**AMENDMENTS TO THE DRAWINGS:**

Attachments: Replacement Sheets

Annotated Sheets Showing Changes

FIG. 1

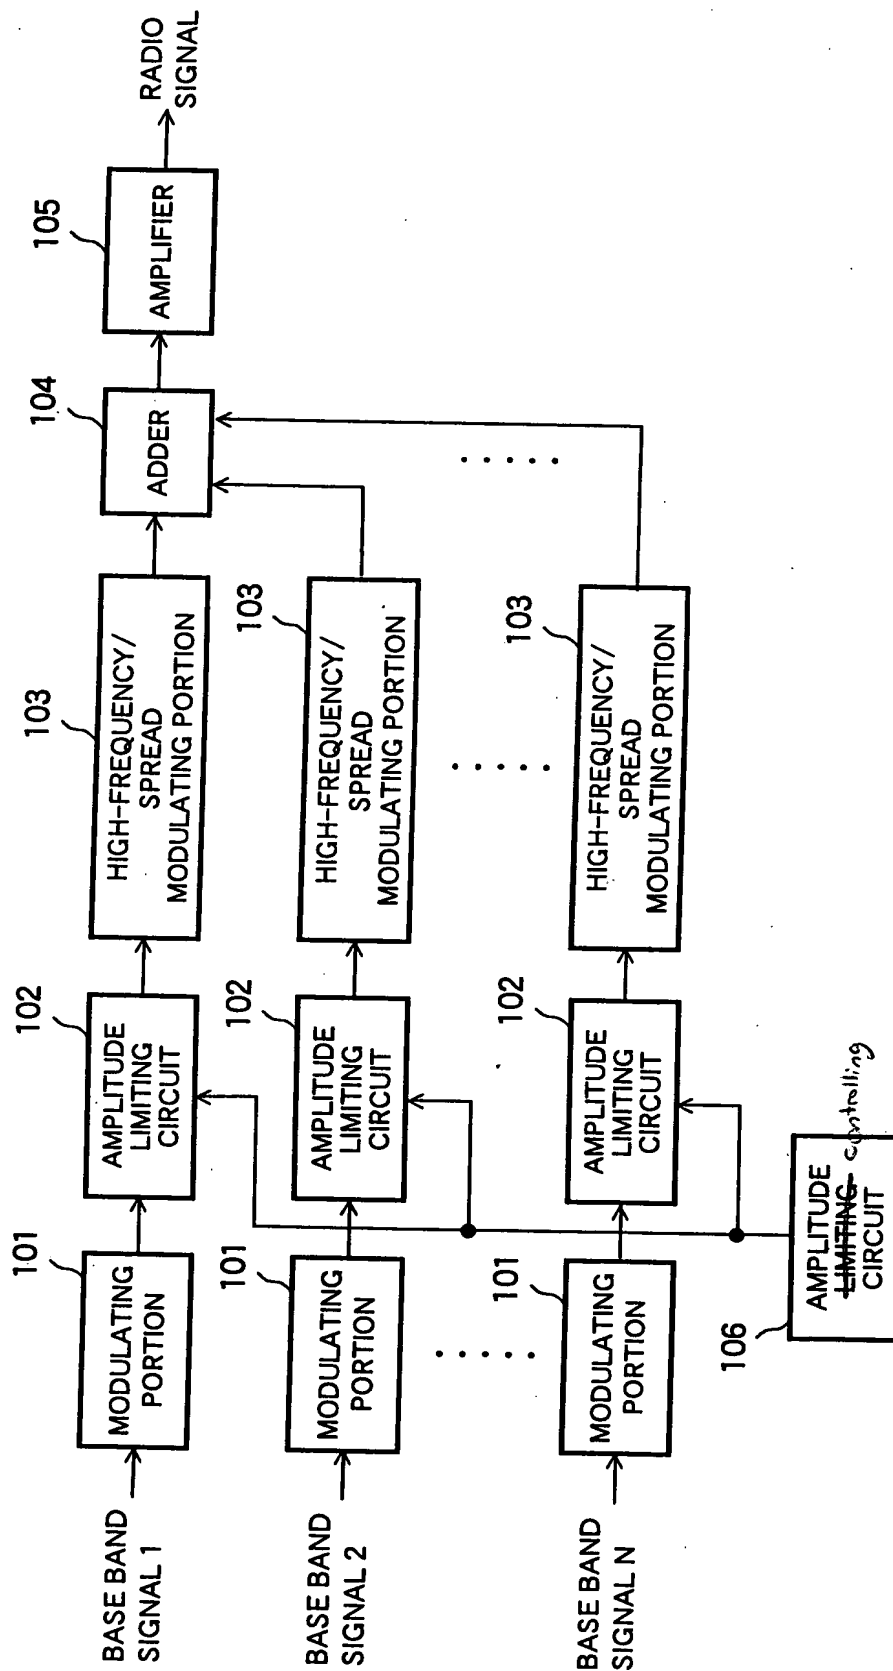
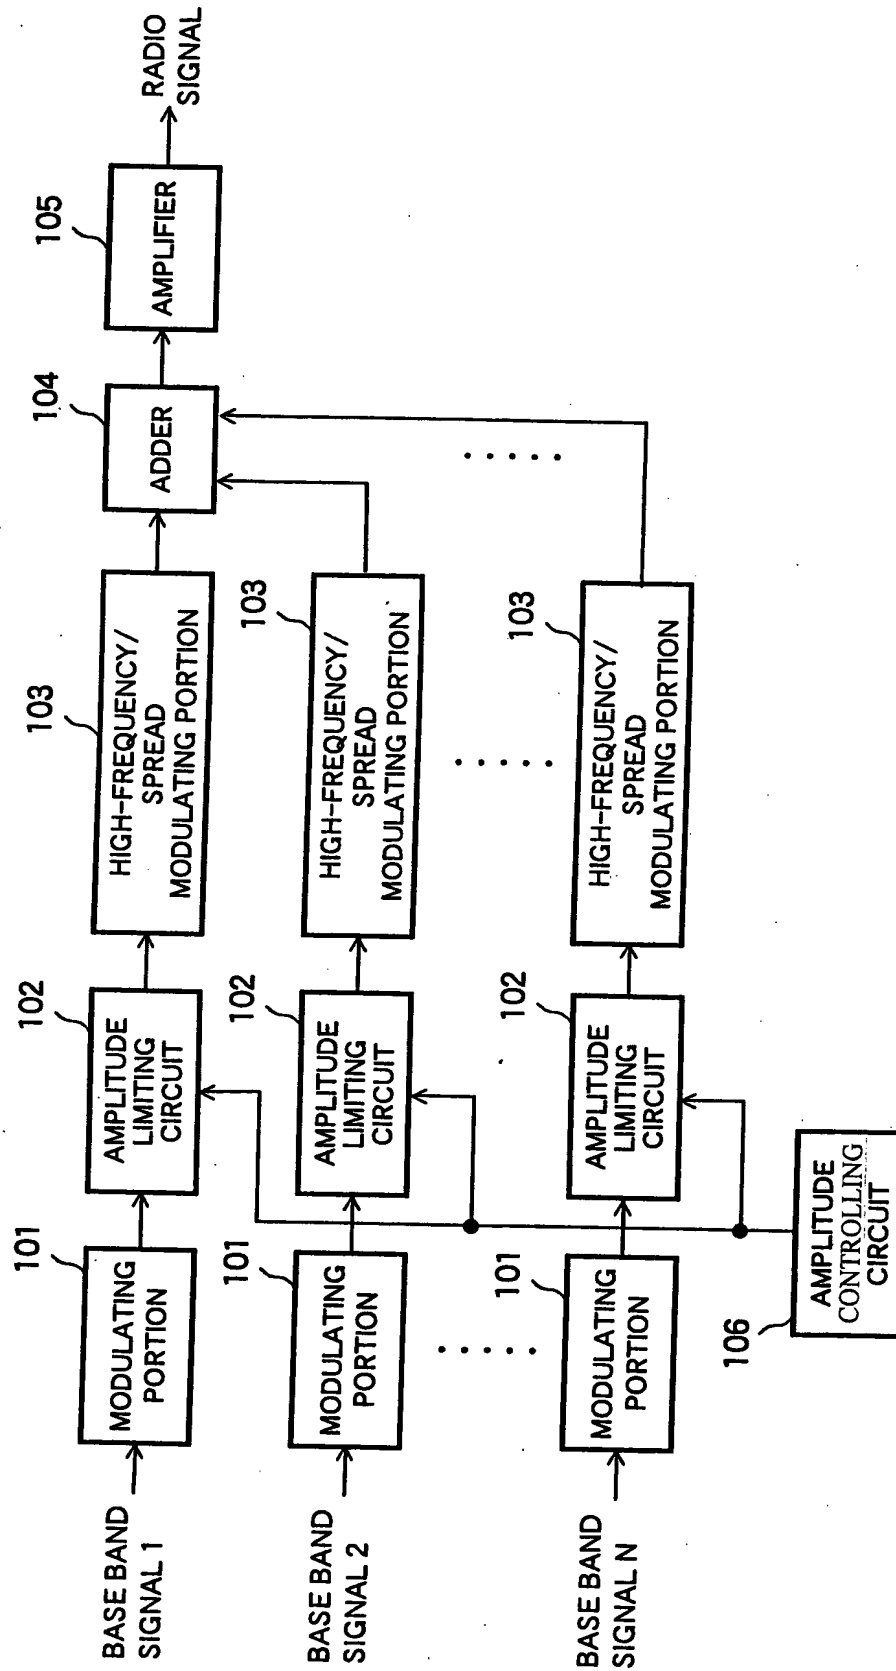
The attached sheets of drawings include changes to Figures 1 and 3. Specifically, Applicants have amended the Figures to replace the phrase “amplitude *limiting* circuit” with the phrase “amplitude *controlling* circuit” in reference numeral 106 in each of Figures 1 and 3. These sheets which include Figures 1 and 3 replace the original sheets which include Figures 1 and 3.
